Return To Library > Records 2 > ERID-108000 through ERID-108499 > ERID-108127 1) APPROVAL PERCHED INTERMEDIATE WELL R-47I WELL DESIGN EMAIL

From: Mark Everett
To: "Liz English"
Cc: "Ted Ball"
Subject: FW: Perched Intermediate Well R-47i Well Design
Date: Monday, November 09, 2009 10:33:00 AM
Attachments: Perched Intermediate Well R-47i Well Design (232 KB).msg

From: David Broxton [mailto:broxton@lanl.gov]
Sent: Thu 11/5/2009 4:47 PM
To: Cobrain, Dave, NMENV; Kulis, Jerzy, NMENV; Dale, Michael, NMENV
Cc: meverett@lanl.gov; tedball@lanl.gov; HShen@doeal.gov; Thomas J. Whitacre; katzman@lanl.gov; andybaumer@lanl.gov; huberpr@lanl.gov
Subject: Perched Intermediate Well R-47i Well Design

R-47i Recommended Well Design

Figure 1. Proposed well design, R-47i.

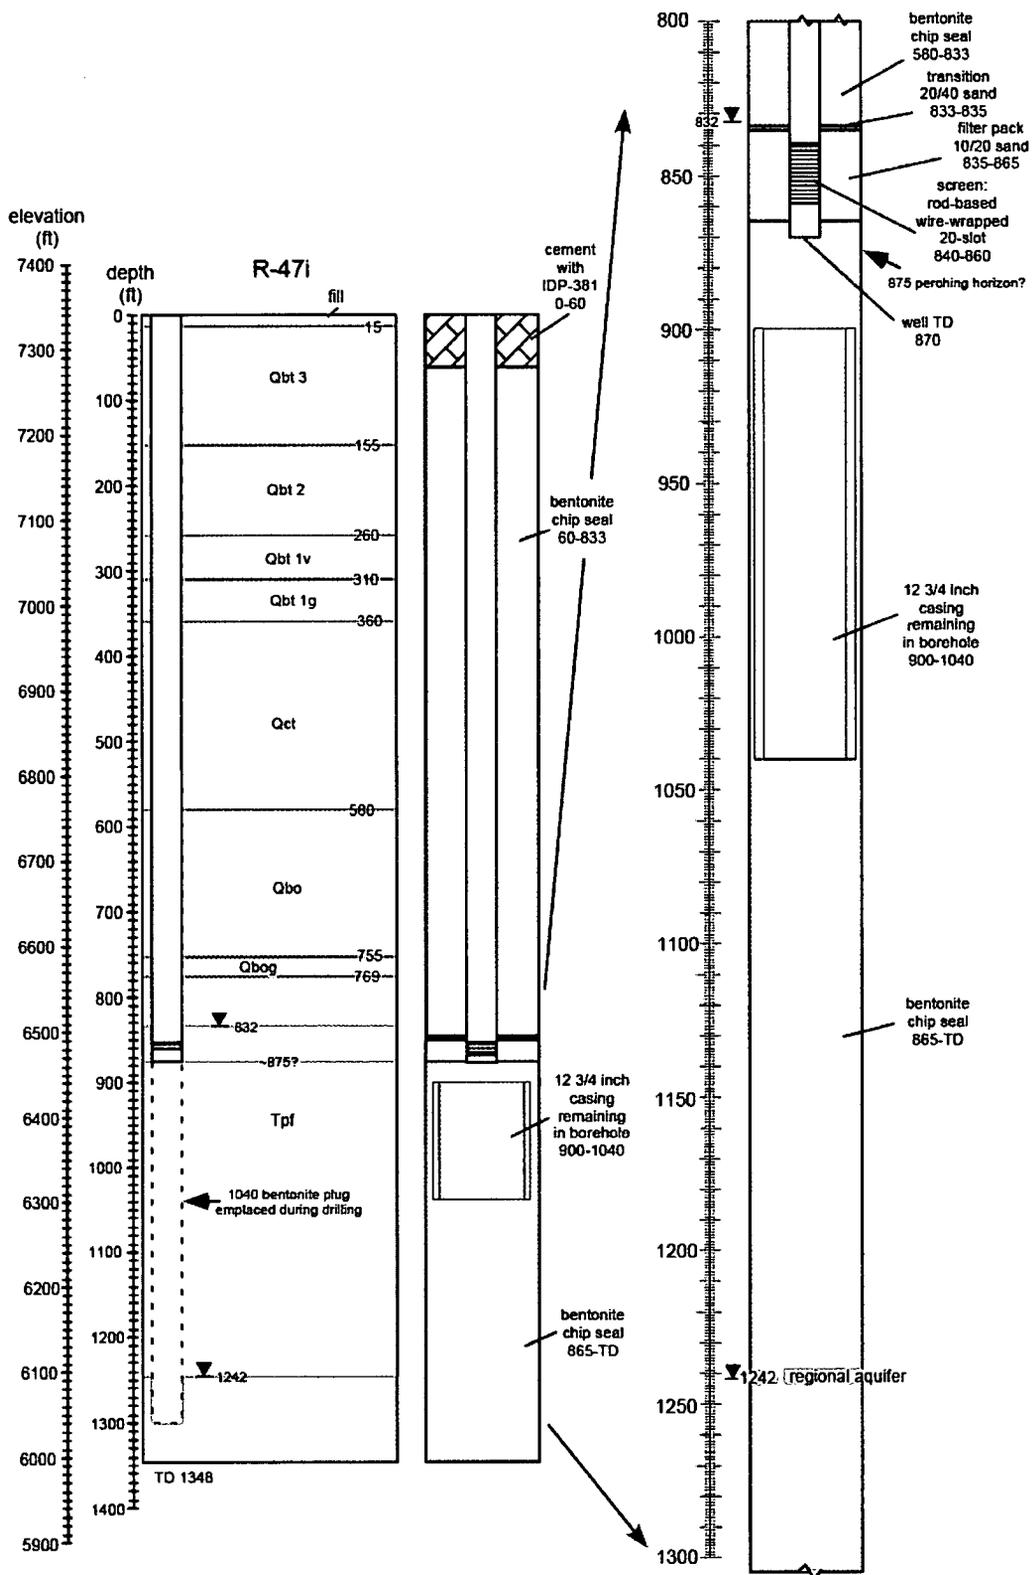
This e-mail serves as NMED approval for installation of intermediate aquifer well R-47i as proposed in the document attached to the original e-mail received by NMED yesterday (November 5, 2009 at 4:47 PM). This approval is based on the information available to NMED at the time of the approval. NMED understands that LANL will provide the results of preliminary sampling, any modifications to the well design proposed in the above-mentioned e-mail, and any additional information related to the installation of well R-47i as soon as such information becomes available. NMED advises LANL to give notice of this installation to the New Mexico Office of the State Engineer as soon as possible. Thank you.
